MORGANTOWN PLANNING COMMISSION

STAFF REPORT

CASE NO: TX13-02 / Administrative / Parking Development Standards

STAFF REPORT ADDENDUM A

Graphic 1365.09.01: "Parking Angles"

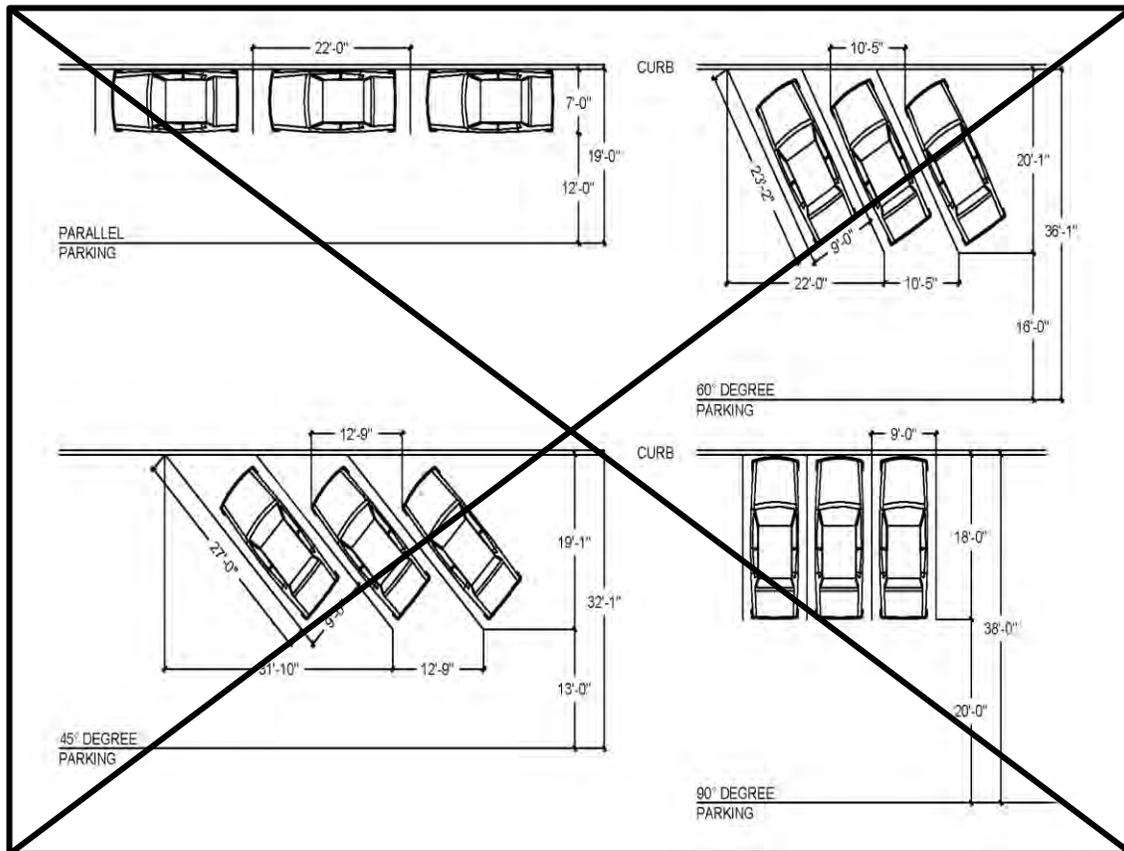
Staff proposes to modify the size of both standard and compact parking stalls and reestablish a maximum proportion for compact stalls. Additionally, by changing the geometry of the parking stall dimensions, related refinement to angled parking and aisle dimensions becomes necessary (see Addendum A).

- (1) Each required off-street standard parking space shall be at least ~~nine (9)~~ eight and one half (8.5) feet in width and at least eighteen (18) feet in ~~length~~ depth, exclusive of access drives or aisles, ramps, columns, or office or work areas. Such space shall have adequate vertical clearance. ~~For compact stalls, the size may be reduced to seven (7) feet by sixteen (16) feet. Angled parking lots shall conform to the design standards illustrated in Graphic 1365.09.01.~~

<u>Parking Angle</u>	<u>Stall Type</u>	<u>Width of Stall (feet)</u>	<u>Depth of Stall Perpendicular to Aisle (feet)</u>	<u>One-Way Aisle Width (feet)</u>	<u>Two-Way Aisle Width (feet)</u>
45°	<u>Standard</u>	<u>8.5</u>	<u>17.5</u>	<u>12.0</u>	<u>20.0</u>
	<u>Compact</u>	<u>8</u>	<u>16.0</u>	<u>12.0</u>	<u>20.0</u>
60°	<u>Standard</u>	<u>8.5</u>	<u>19.0</u>	<u>16.0</u>	<u>20.0</u>
	<u>Compact</u>	<u>8</u>	<u>17.0</u>	<u>15.0</u>	<u>20.0</u>
90°	<u>Standard</u>	<u>8.5</u>	<u>18.0</u>	<u>20.0</u>	<u>20.0</u>
	<u>Compact</u>	<u>8</u>	<u>15.0</u>	<u>20.0</u>	<u>20.0</u>
<u>Parallel</u>	<u>Standard</u>	<u>22.0</u>	<u>7.5</u>	<u>12.0</u>	<u>20.0</u>
	<u>Compact</u>	<u>19.0</u>	<u>7.5</u>	<u>10.0</u>	<u>20.0</u>
